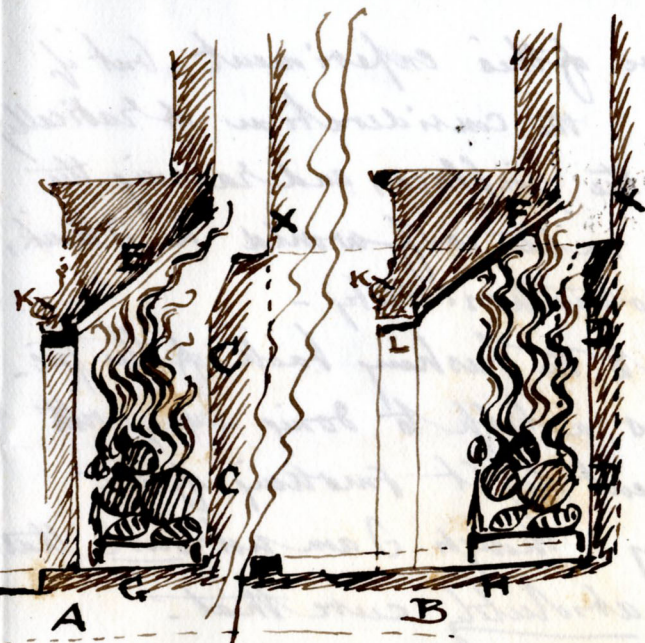
On again consulting the drawings, I have concluded that the small reduction of the size of the opening of the ^{fall} fire-place is not the chief cause of the mischief, but rather, that the heat at its greatest - just over the burning logs - strikes against the rather flat incline of the hood, and makes the whole of the brick & tile work there (in spite of the iron shield) so hot, that expansion & contraction goes on; which movement, more than the actual radiated heat to the ^{black} marble, cracks the latter,

as well as - so I fancy - even acting
on the work over so as to discolour it,
over & above the discolouration from
the slight smoking at the mouth of
the opening.

What I proposed in my last letter as a
slight modification to meet the evils,
as suggested above, I here shew
with small rough sections A & B -

The hearth G is lowered at H -

The back to fire C - C (which is an
addition to the face of the old wall
X - X) I would reduce from its
present thickness at C - C to that
at D - D - This would throw the
point of greatest heat - E, farther
back as indicated (not by scale) at
F, the fire dogs being placed about 6"
back - This putting the fire dogs

back and the additional height given
by lowering the hearth, might make
a very considerable difference in the
amount of expansion & contraction.

I would, also, replace the black
marble frame, which is exceedingly
brittle, with grey Sicilian marble
of the same kind as the architrave K
and I would extend the shield L as
you suggest. I will readily bear
